**Re: Revised Application of Merrion Oil & Gas  
Non-Standard "Off Pattern" Location  
Shank Com #1  
Basin Fruitland Coal Pool  
NW/4 Section 2, T26N, R13W  
San Juan County, New Mexico**

*RE: Administrative application for an unorthodox "off-pattern" coal gas well location within the Basin-Fruitland Coal (Gas) Pool for the proposed Shank Com. Well No. 1 (API No. 30-045-29516), to be drilled 1840 feet from the North and East lines (Unit F) of Section 2, Township 26 North, Range 13 West, NMPM, San Juan County, New Mexico.*

**Re: Application of Merrion Oil & Gas Corporation  
Non-Standard Location  
Shank Com #1  
Basin Fruitland Coal Pool  
NW/4 Section 2, T26N, R13W  
San Juan County, New Mexico**

# EXHIBIT 3

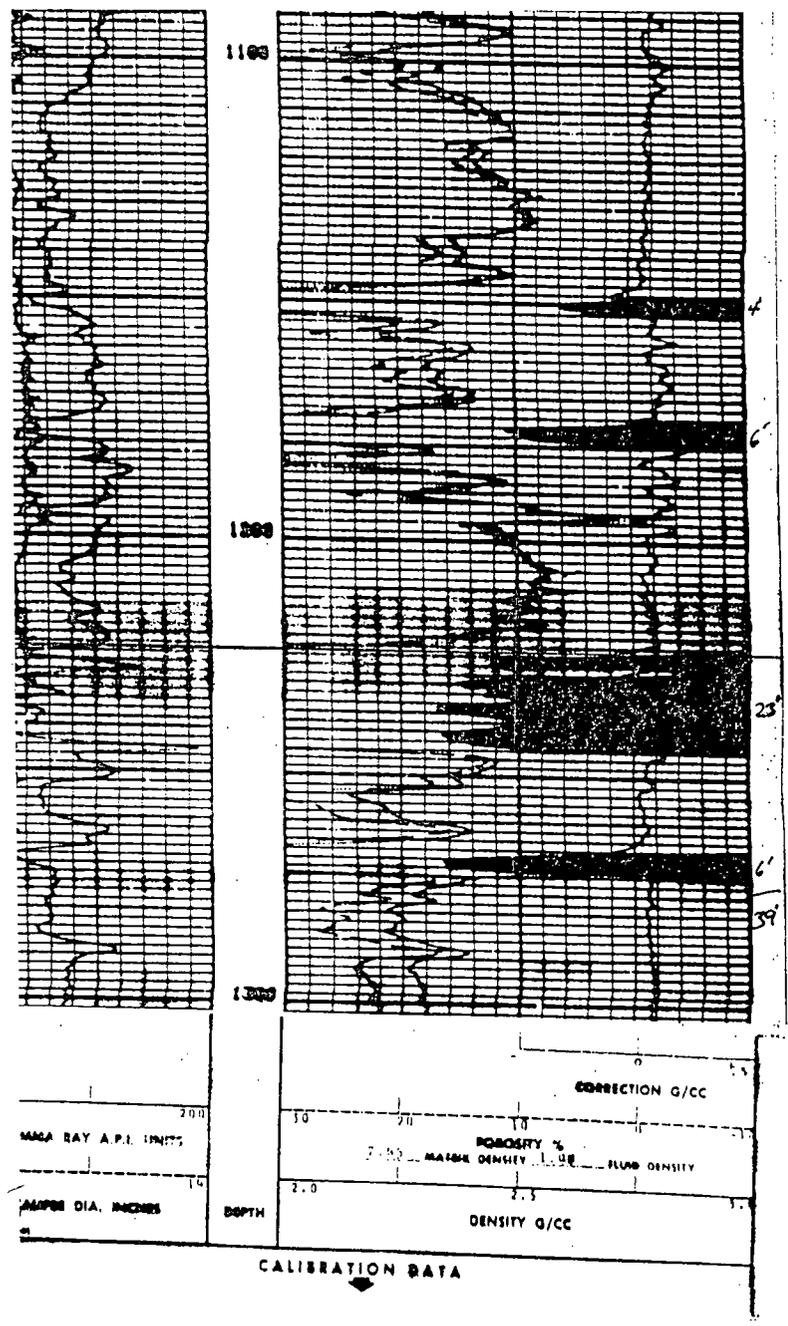
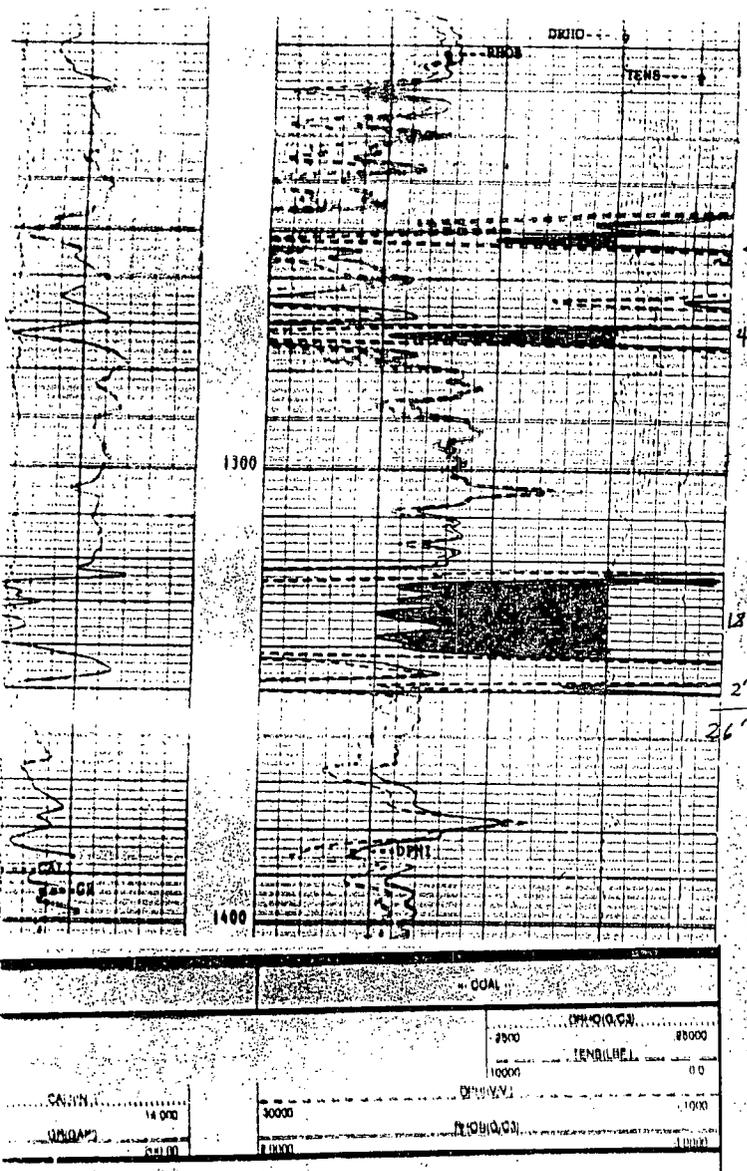
Merrion is proposing to drill the well on the northern part of the spacing unit for geologic reasons. Exhibit 3 is a log cross-section showing that the coal thickness increases to the north and east across the project area. The total coal thickness of approximately 26 feet in the SW/4 of Section 10 increases to 39 feet in the NW/4 of Section 2, T26N, R13W, where Merrion proposes to drill the well.

In reference to the Shank Corn #1 well of Merrion's, I don't believe their application is justified for geologic exception. There is no substantial difference in the pay (exhibit #3), and a Southwest ¼ location is desirable because of the well distribution in the surrounding sections. I recommend not approving this application administratively and suggesting a standard location in the SW/4.

# EXHIBIT 4

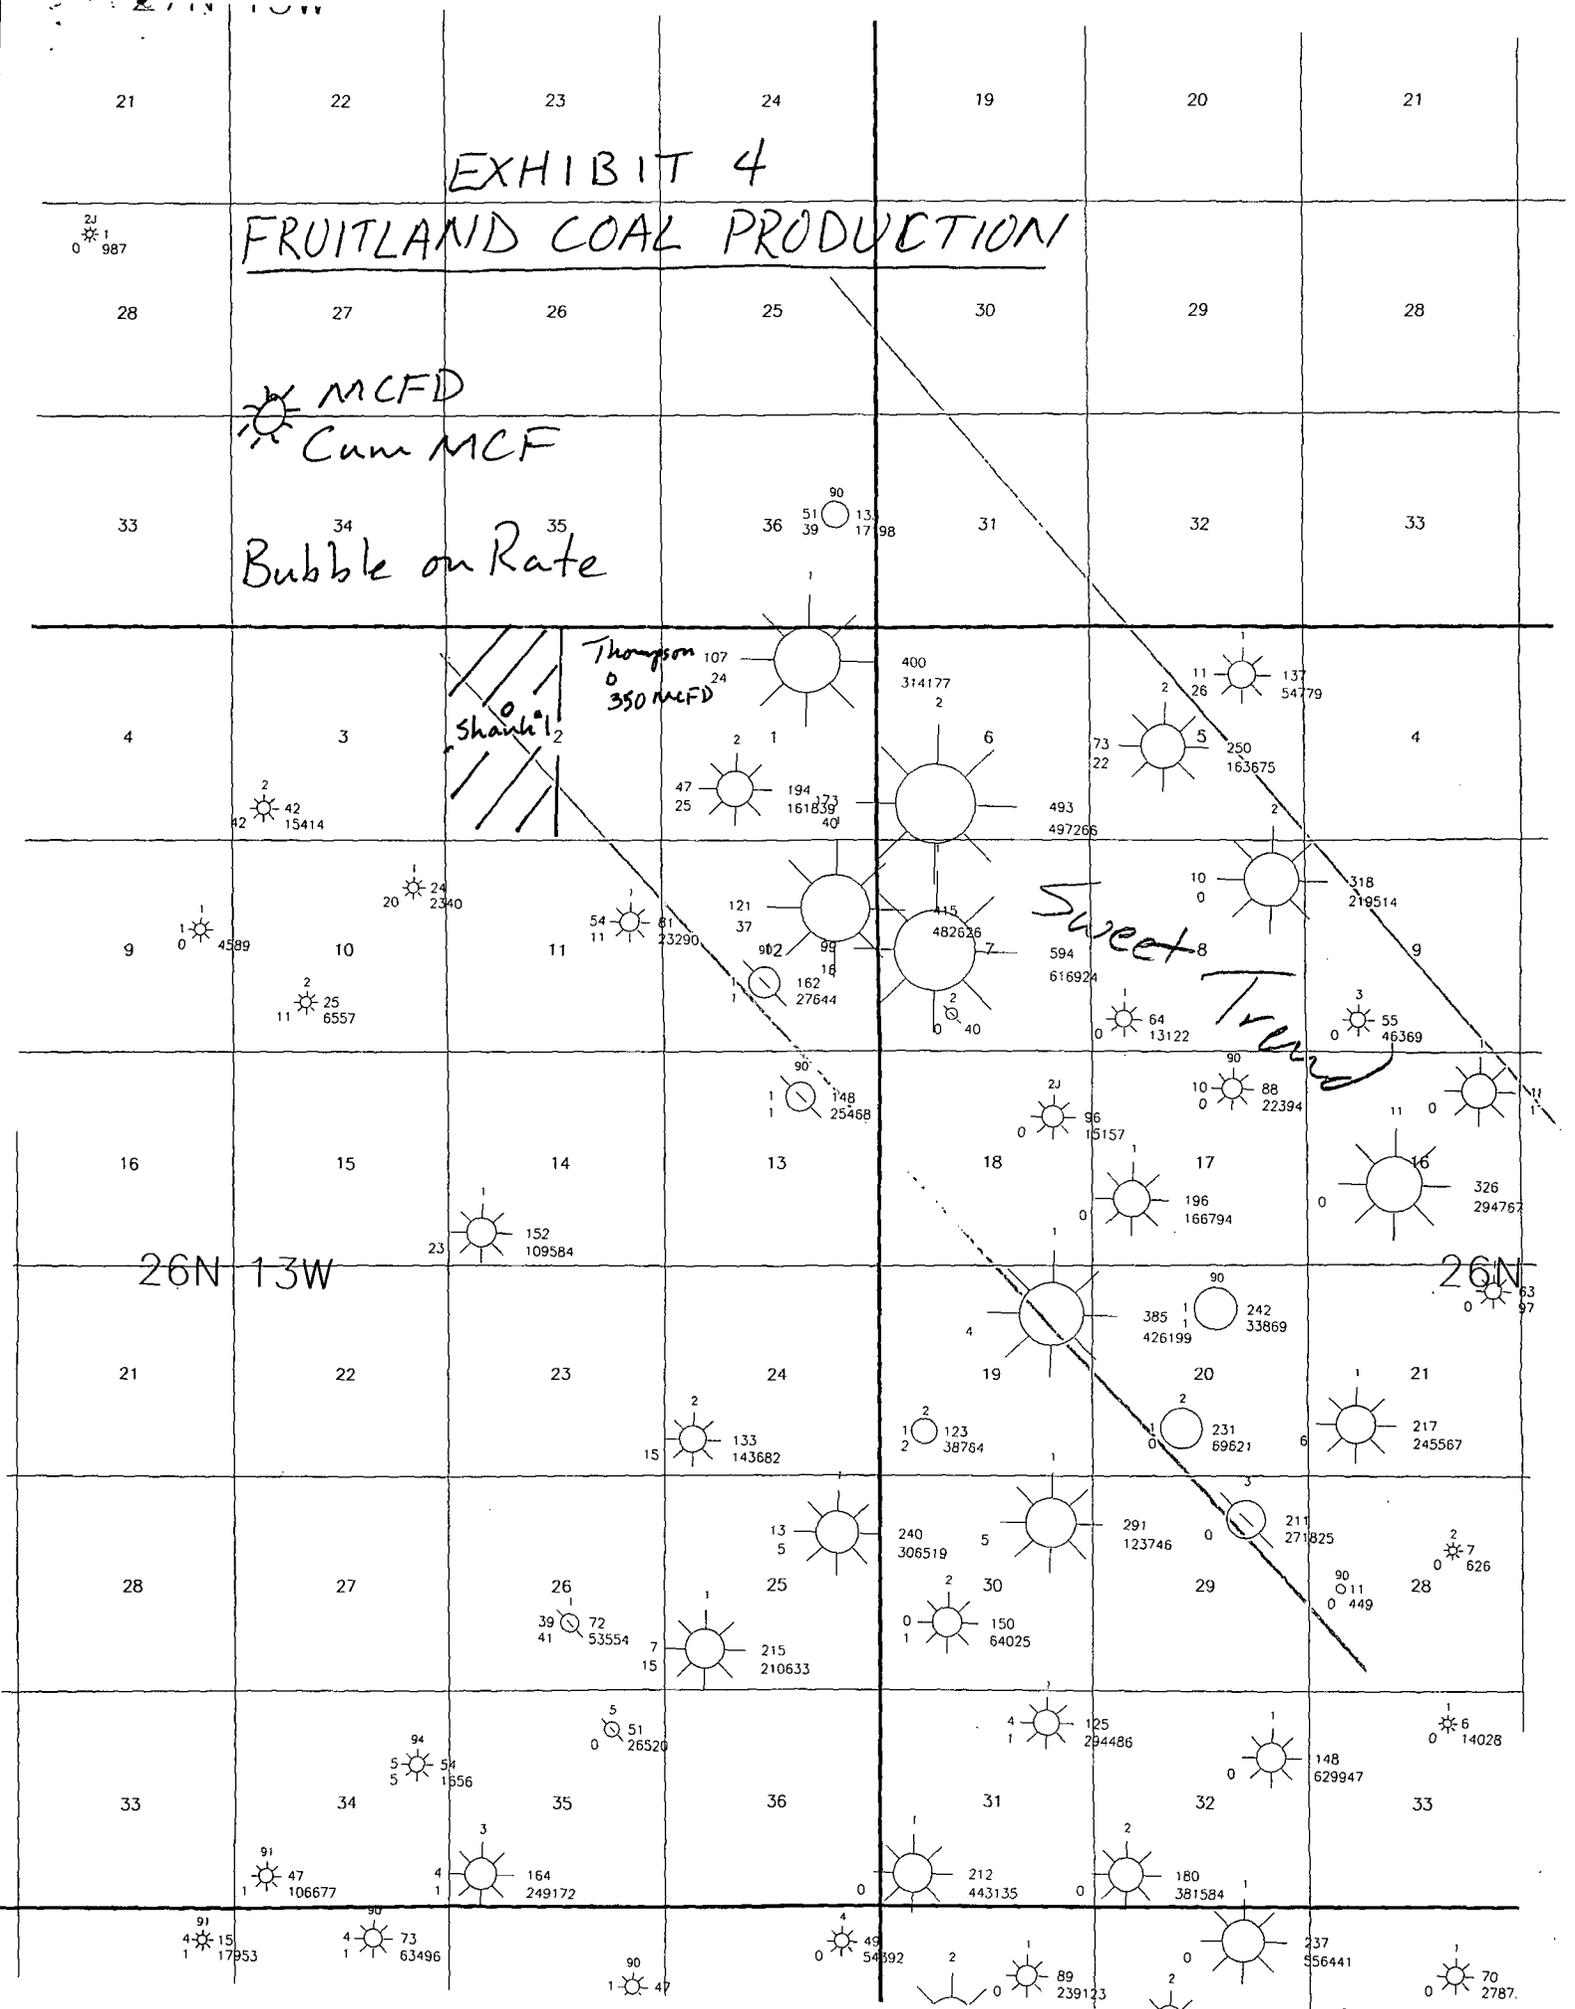
Along with the increasing coal thickness, there is a dramatic improvement in coal quality to the northeast across the project area. Exhibit 4 shows that adjacent wells to the southwest of the Shank Com #1 spacing unit are uneconomic at gas rates of 0 to 42 MCFD. Wells to the northeast in the "sweet trend" as shown on Exhibit 4 are making up to 600 MCFD. This dramatic improvement in well performance indicates a substantial improvement in coal quality and cleating to the north and east.

This is concerning the Shank Com #1 well that we denied as an administrative application, on the first go around. Merrion resubmitted additional information of a geologic nature that helped their case. There was no offset opposition and I also talked to the BLM and they did not have a position. So I recommend we grant Merrion's application administratively.

# EXHIBIT 3

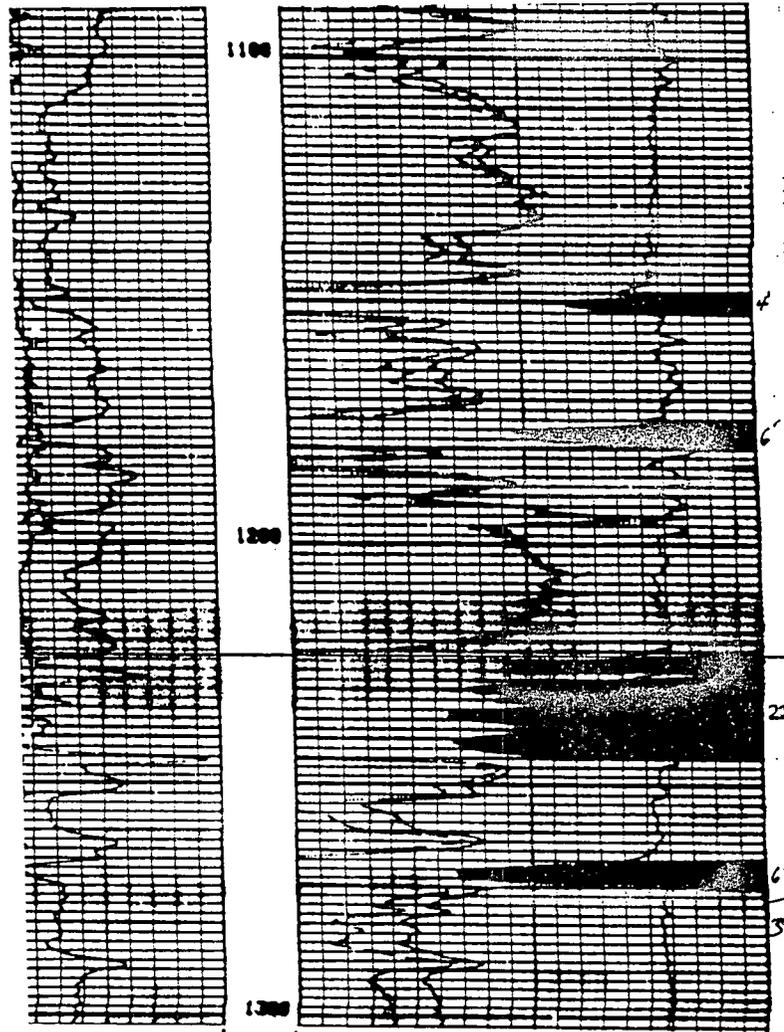
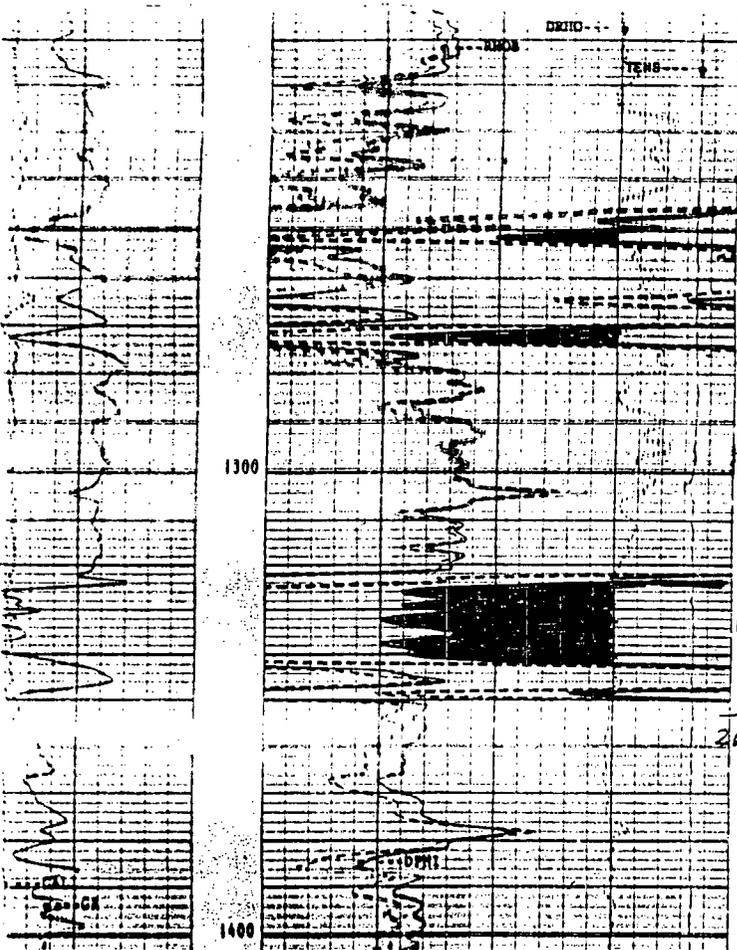
Merrion is proposing to drill the well on the northern part of the spacing unit for geologic reasons. Exhibit 3 is a log cross-section showing that the coal thickness increases to the north and east across the project area. The total coal thickness of approximately 26 feet in the SW/4 of Section 10 increases to 39 feet in the NW/4 of Section 2, T26N, R13W, where Merrion proposes to drill the well.
